METROPOLITAN GOVERNMENT OF NASHVILLE AND DAVIDSON COUNTY

STAFF RECOMMENDATION
1423 Stratton Avenue
August 19, 2015

Application: New construction – outbuilding with detached accessory dwelling unit;
Setback determination

SITE PLAN

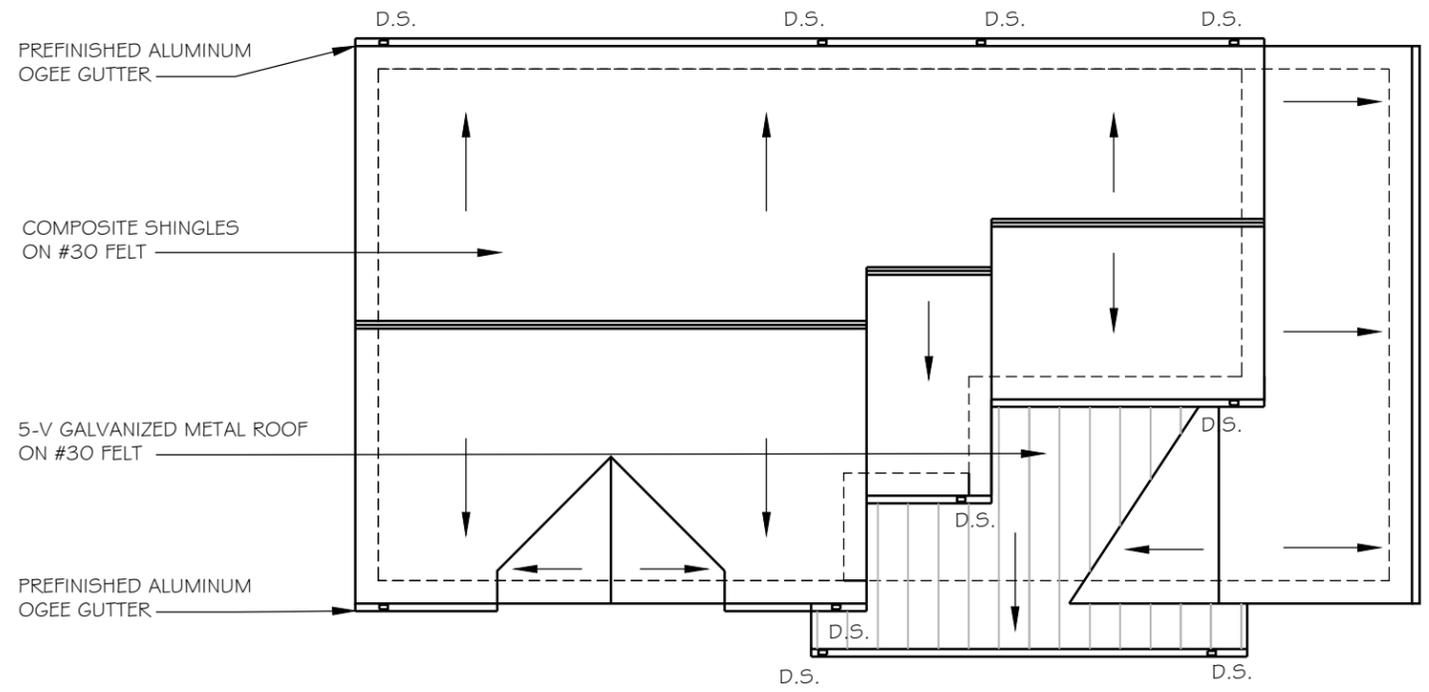
The new outbuilding does require a reduction to the rear setback. When an outbuilding has a footprint greater than seven hundred square feet (700 sq. ft.), base zoning requires that the structure be located twenty feet (20') from the rear property line and five feet (5') from the side property lines. The applicant is proposing to locate the structure five feet (5') from the rear property line. Staff finds that the proposed rear setback is appropriate because historically, outbuildings were located close to or on the rear property line. In addition, the existing outbuilding, which will be added on to in order to create the DADU, is located just five feet (5') from the rear property line.

MINIMUM	PROPOSED
Space between principle building and DADU/Garage	20'	24'
Rear setback	3'	5'
L side setback**	3'	8'
R side setback**	3'	7'6”
How is the building accessed?	From the alley or existing curb cut	Alley

Recommendation Summary: Staff recommends approval of the detached accessory dwelling unit and setback determination with the following conditions:

1. Staff receive a restrictive covenant for the Detached accessory dwelling unit use;
2. Staff approve the final details, dimensions and materials of windows and doors prior to purchase and installation; and,
3. Staff approve the roof color and masonry color, dimensions and texture.

ELEVATIONS

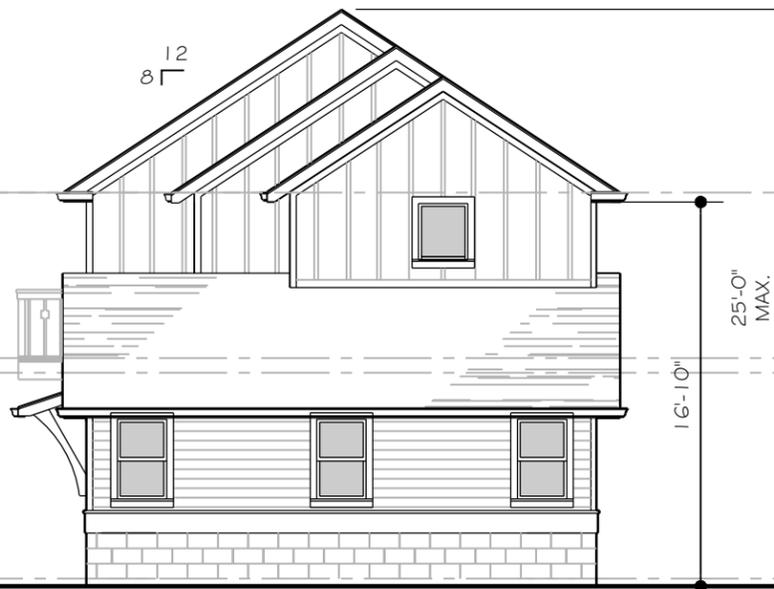
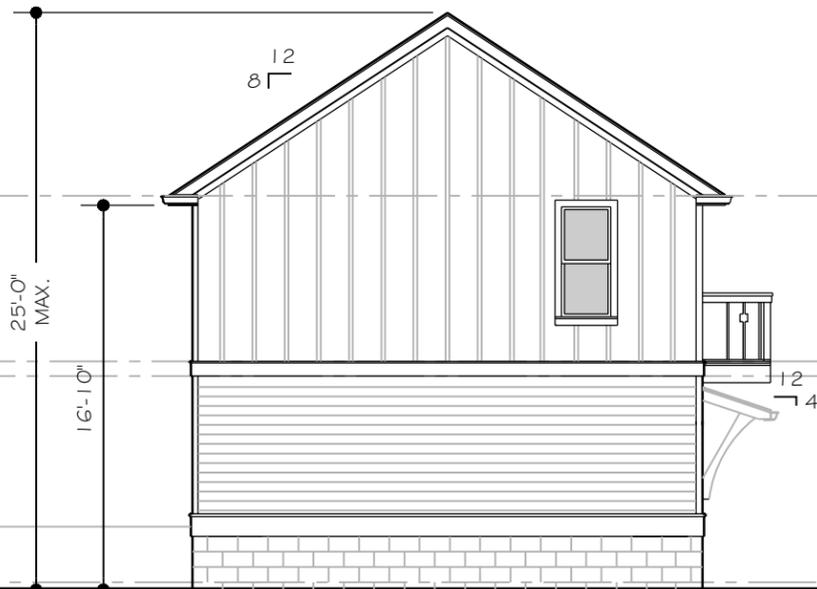
The proposed DADU will be two stories and will have a footprint of one thousand square feet (1,000 sq. ft.). Staff finds this to meet the DADU ordinance since the primary structure is two-stories, and the lot is ten thousand, two hundred square feet (10,200 sq.ft.) in area. The DADU will be twenty-five feet (25’) tall, with an eave height of

sixteen feet, ten inches (16'10"). It will be at least ten feet (10') shorter than the historic house. The materials for the DADU have all been approved by the Commission in the past, and include cement fiber board siding with a five inch (5") reveal, cement fiber board and batten, cement fiber trim, composite shingles, a metal roof, and a split face block foundation. Staff recommends approval of the shingle and the metal roof color. The window and doors will be aluminum clad, and staff recommends approval of the window and door selections prior to purchase and installation.
